**Design Review & Historic Preservation Board
Agenda
November 10, 2022**

Design Review and Historic Preservation Board
Minutes
October 27, 2022

SCALE: 3/16" = 1'-0"

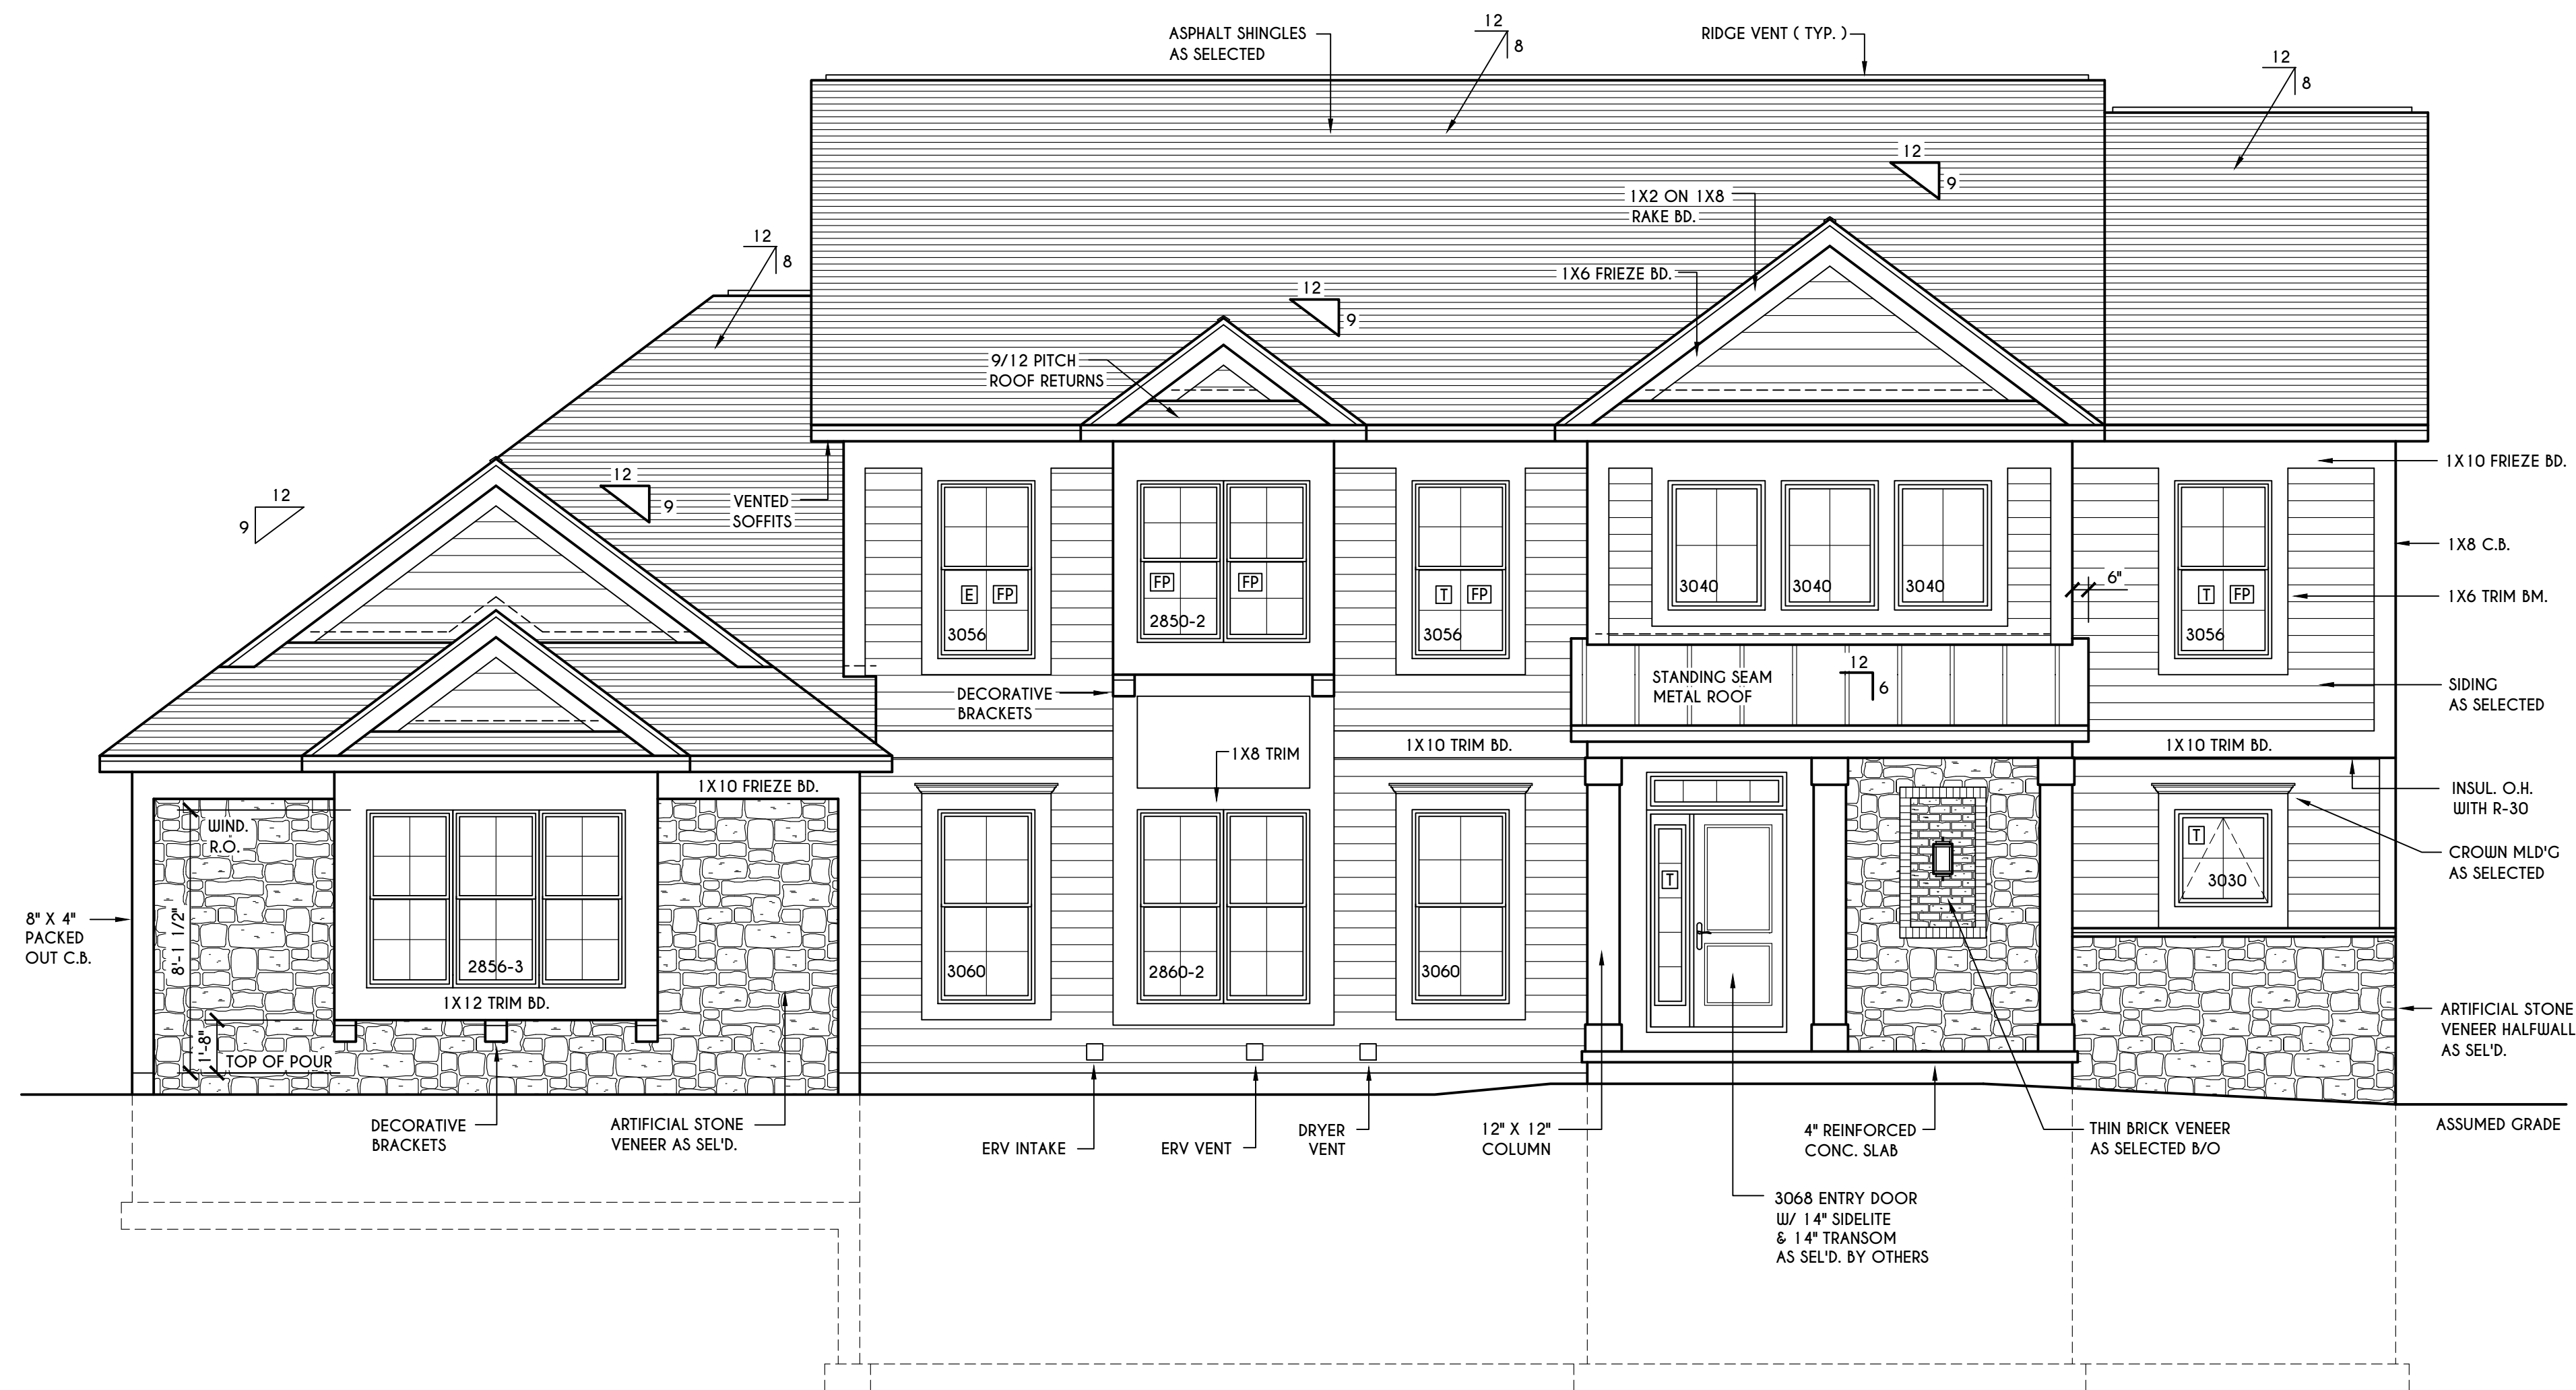
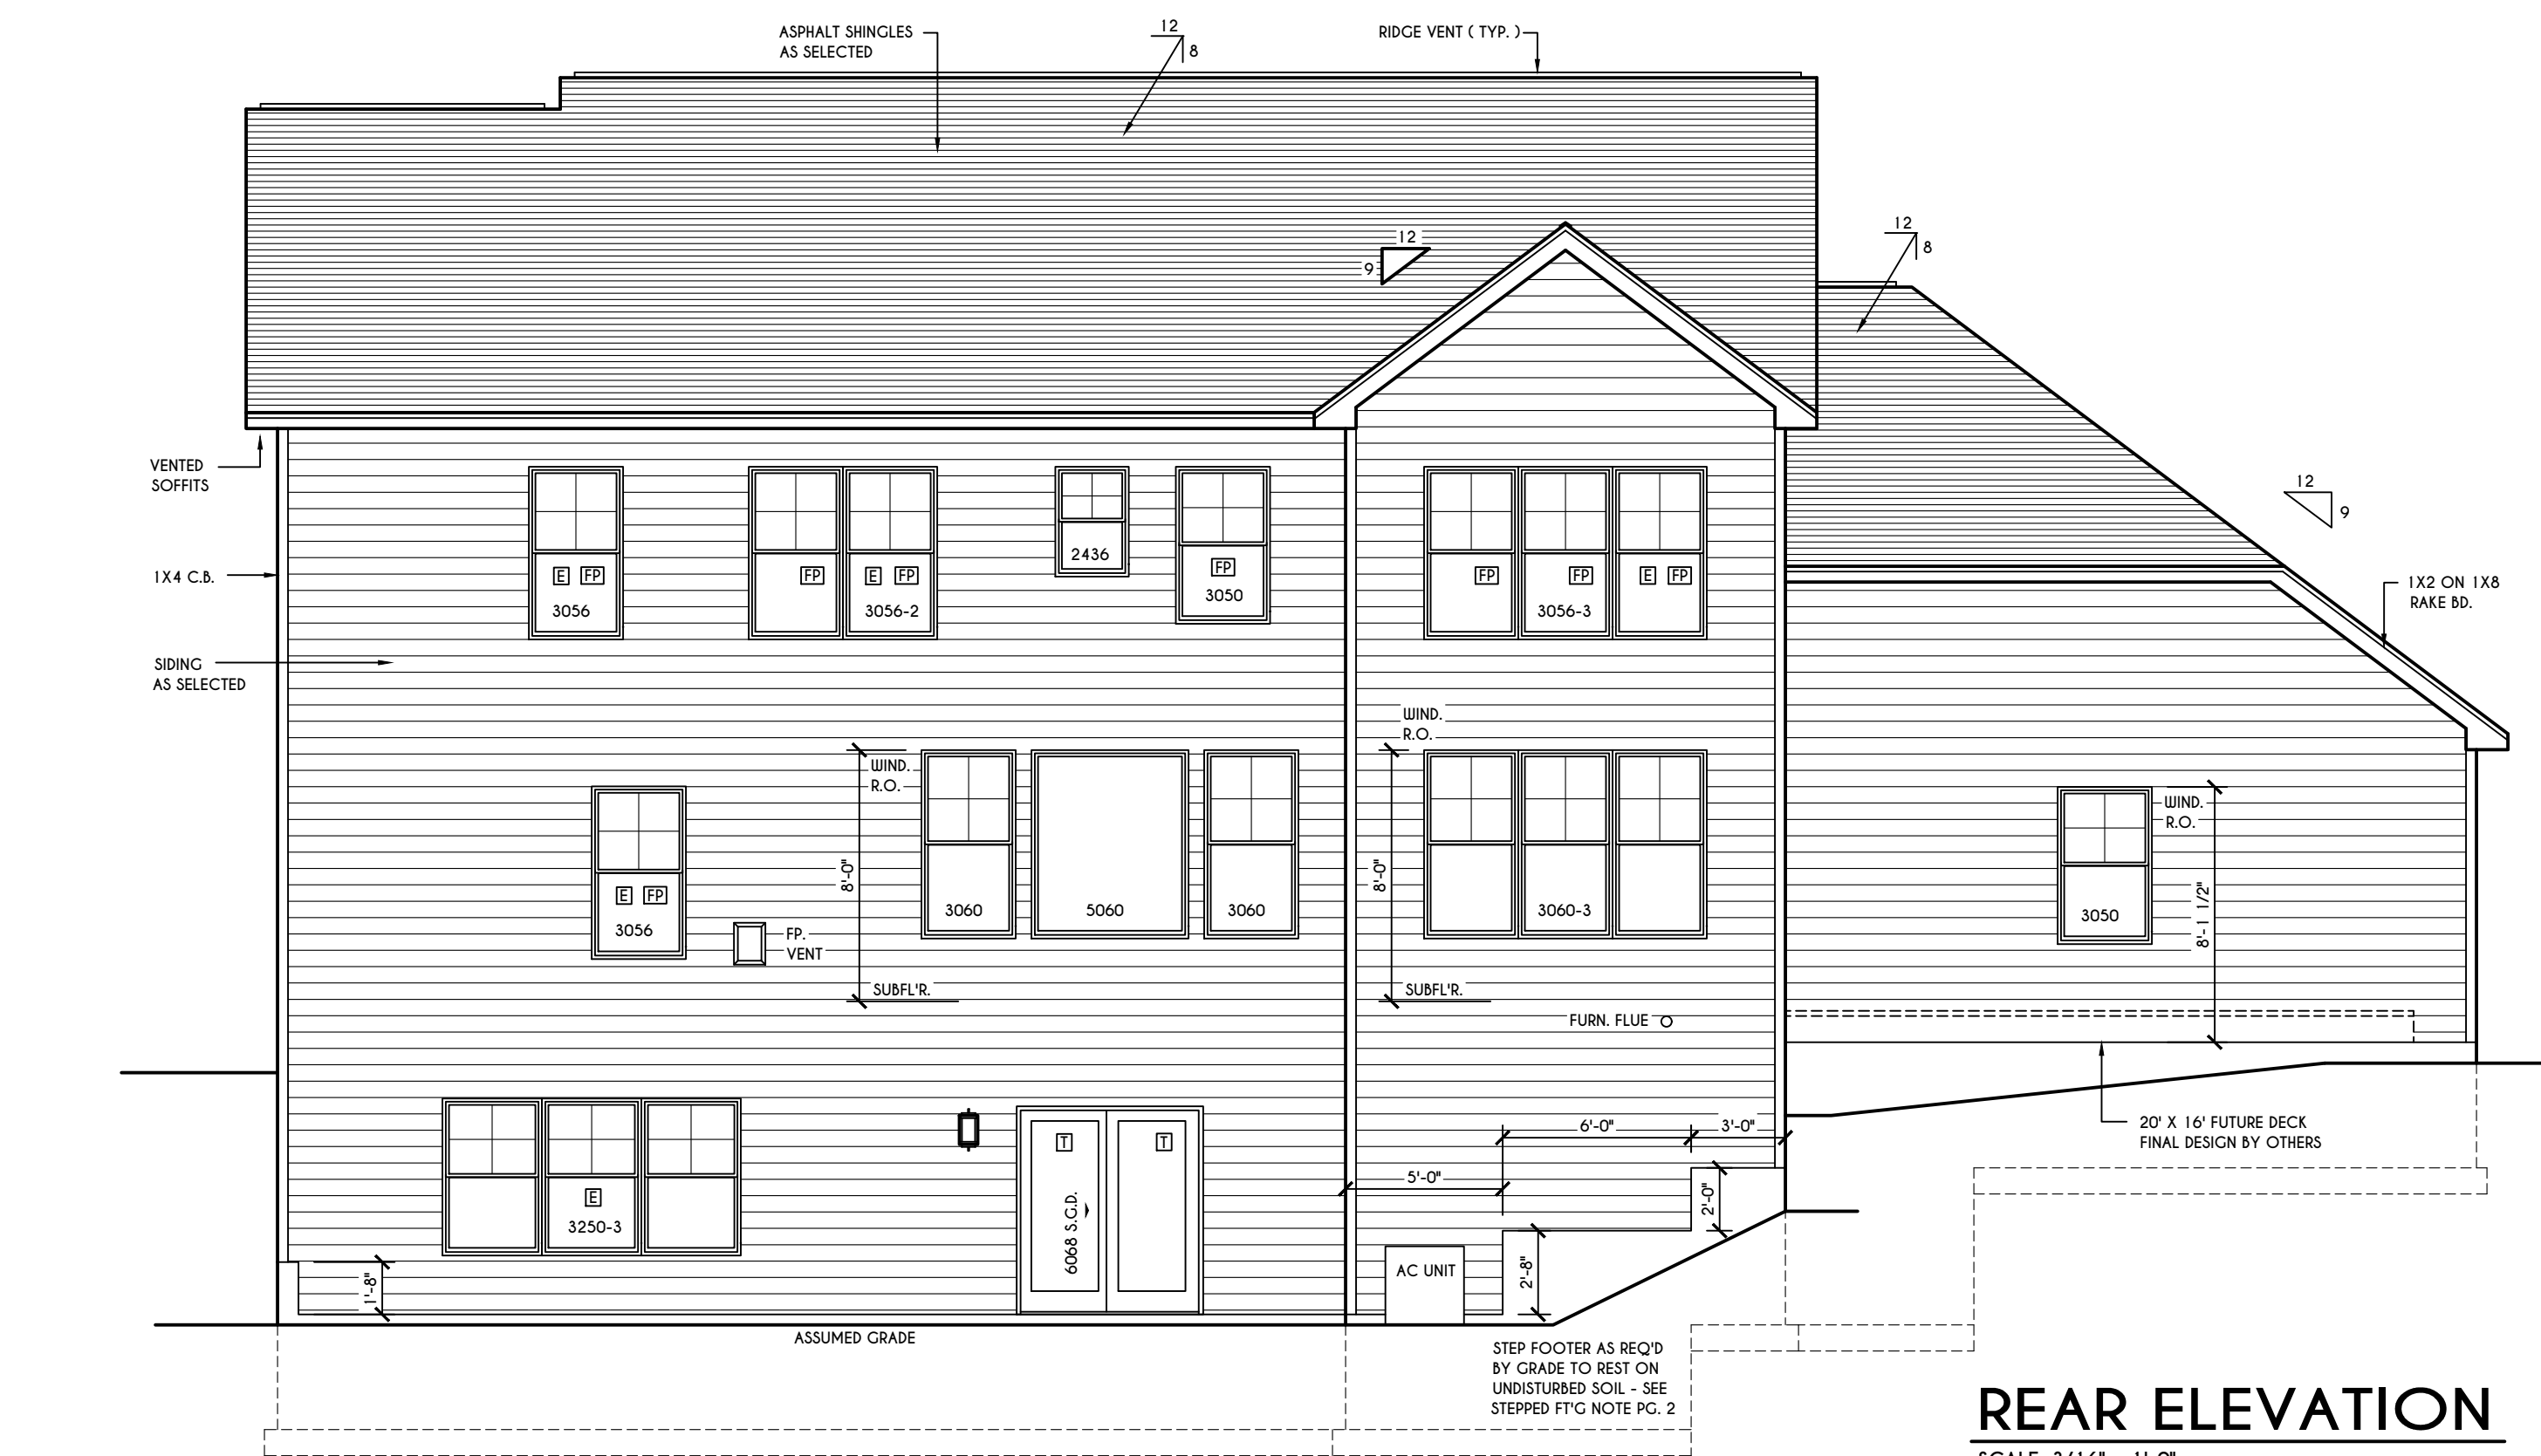
The Board had concerns about the multiple materials utilized on the front elevation. They felt the front elevation is “busy” and preferred 1 or 2 textures as opposed to brick, siding, board and batten and timbers in addition to two roofing materials. Bonnie Salem recommended that the siding replace the board and batten. After discussion, the Board determined that if the color palette is the same and compatible with the brick this design would be acceptable.

David Wigg moved to accept the application as submitted with conditions:

1. The metal roof and asphalt roof will be the same color.
2. The color palette of the materials will be the same color palette and the brick will be compatible.

**PLOT PLAN - LOT C2
 WILSHIRE HILL - SECTION 2**

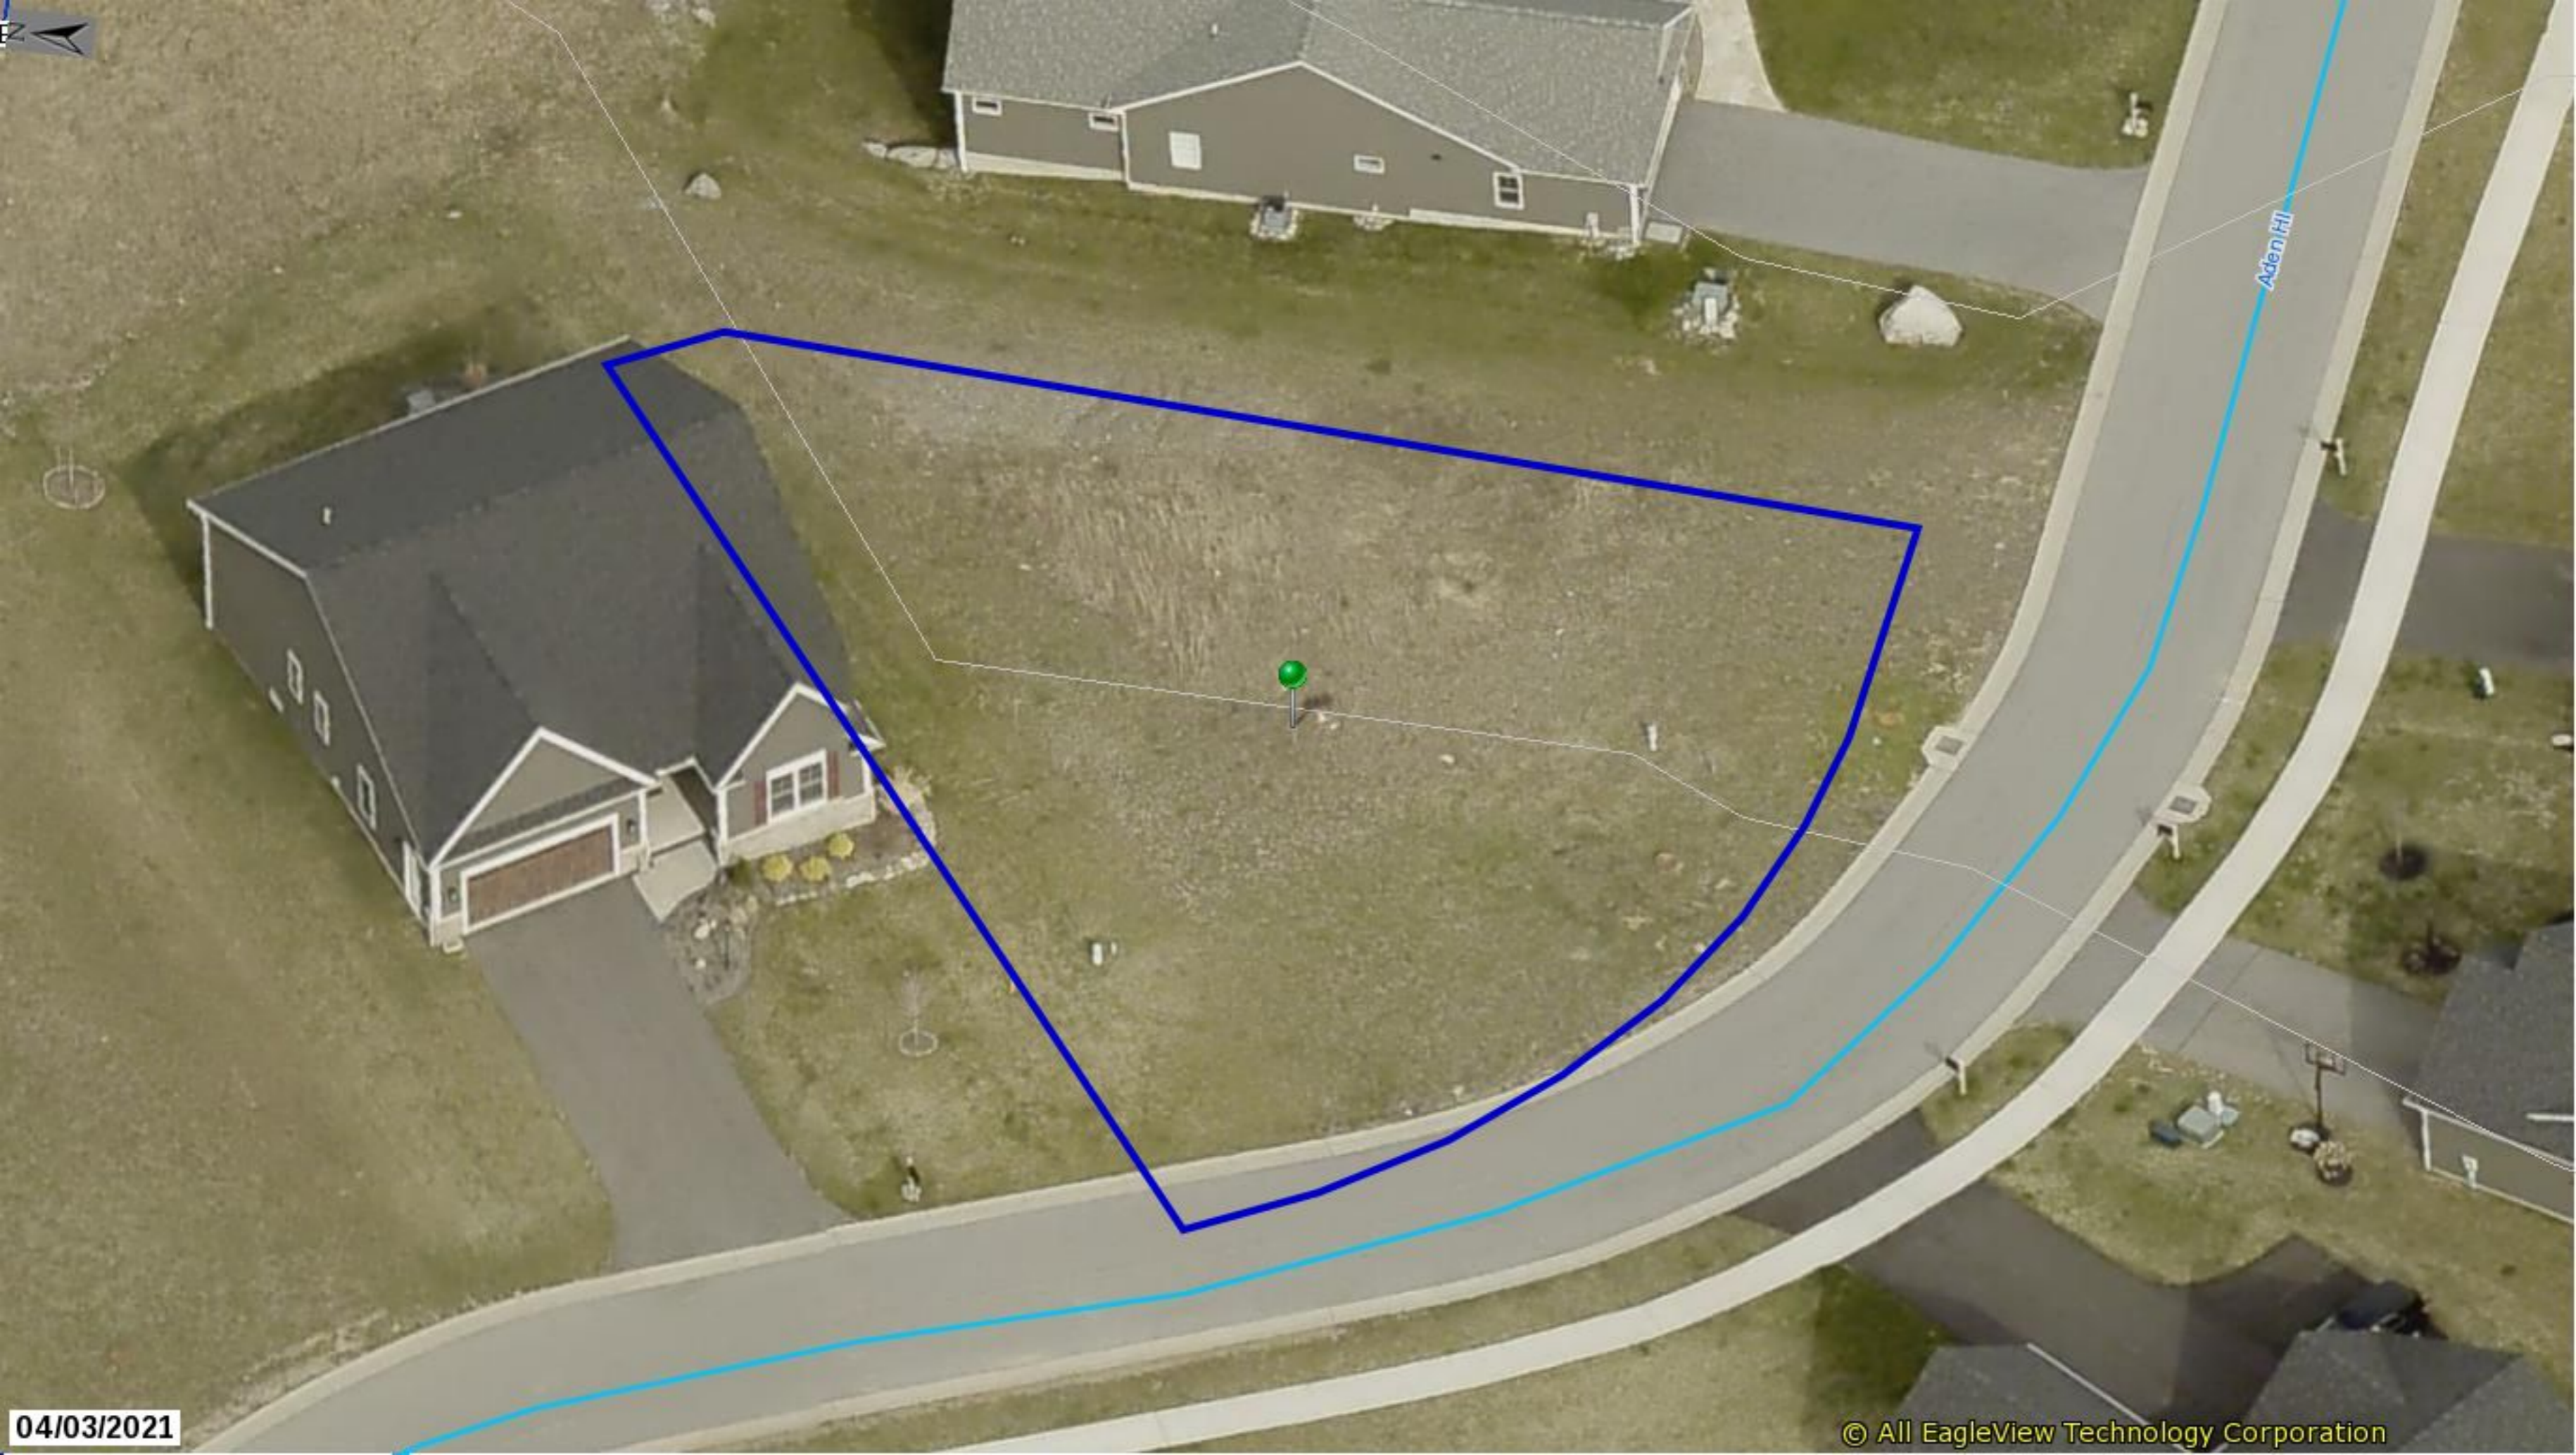
The Board requested to have further information on how the proposed house will sit on the property due to the corner location of this pie shaped lot.
